Colombo Port development works

by

Reginald Duncan Gwyther, C.B.E., M.C., M.Sc., M.I.C.E.

Alfred Proom Humble, M.B.E., M.I.C.E.

FIG. 19: CROSS SECTION OF WAREHOUSE AT CANAL YARD

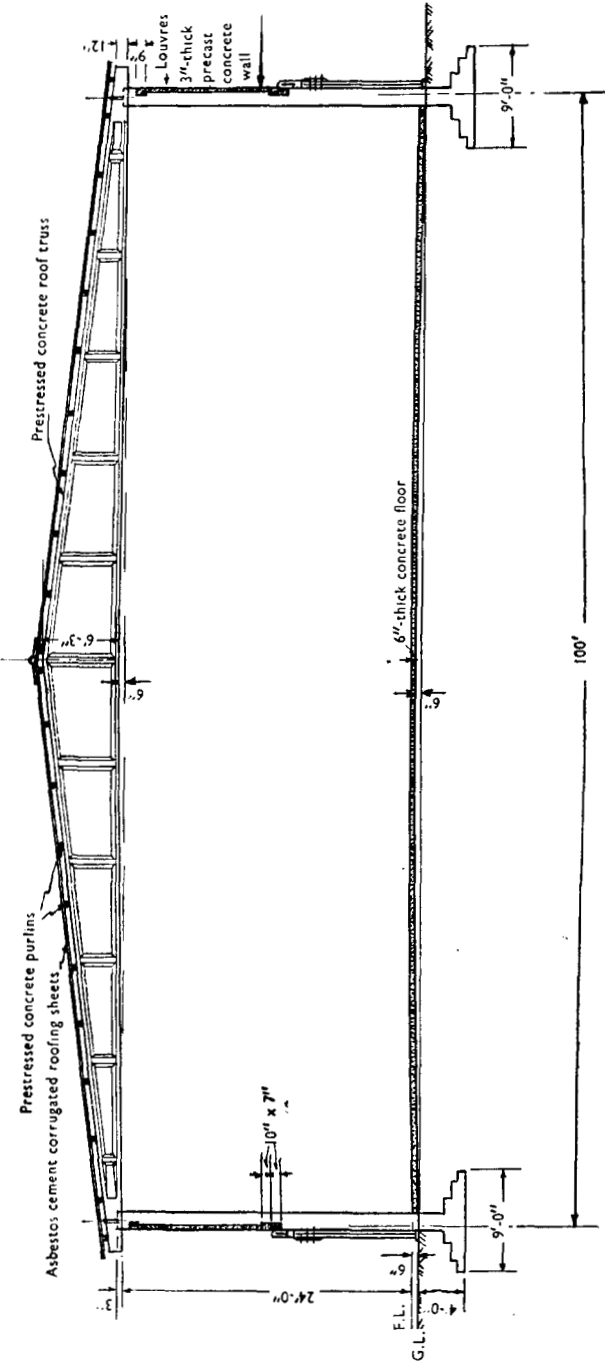
167. At § 10 it was stated that "all transit sheds were of fabricated structural steel work". The cost of these transit sheds has also been given in Table 3. It can be seen that the costs of the transit sheds per sq. ft have varied from Rs.29.50 to Rs.40.50. This figure apparently does not take customs duty into consideration as the materials supplied under the contract were free of customs duty. These rates are considered to be very high when compared to the cost of similar buildings constructed in the Port and elsewhere. These buildings suffer another disadvantage in that they are subject to severe corrosion due to their proximity to the sea and the high humidity in Colombo. This results in considerable expenditure in maintenance which had been over £1000 per year per shed. Considering the high cost of steel in Ceylon and the severe corrosion that steel is exposed to, it would have been expected that more suitable construction materials like reinforced concrete and prestressed concrete would have been used in the construction of these sheds. The contractors themselves had had considerable experience in construction of large structures in prestressed concrete and very good aggregates were also available in Ceylon for the production of high quality concrete. At the time these buildings were constructed high quality concrete (in prestressed concrete structures) was being produced in the Port itself by the Chief Engineer's Department. It is therefore difficult to understand the decision to use expensive structural steel work in the construction of the sheds when the conditions were more favourable for construction in concrete. As an illustration, details of a food warehouse—100 ft span × 410 ft long and 24 ft clear height, constructed in 1955/56 are given in Fig. 19.

168. This building which is very similar in dimensions to the transit sheds constructed under the Port Development Contract, cost less than Rs.20 per sq. ft., inclusive of customs duty and departmental overheads, which had to be added, as the cost was debited to a commercial account of the Food Commissioner. The maintenance of the building has involved only colour washing it once in about 2 or 3 years, and the annual maintenance cost has therefore been less than Rs.1000 when compared to over £1000 for the transit sheds constructed in structural steel work.

186. In the Author's recent experience a shed 400 ft by 150 ft constructed in precast reinforced concrete in 1960, showed a saving over a similar shed constructed in steel of 14%, when stresses of 1400 lb/sq. in. for concrete and 20 000 lb/sq. in. for steel bars were accepted. It is doubtful, however, whether such saving would have been achieved in 1950. The sheds in question were three bay spans.
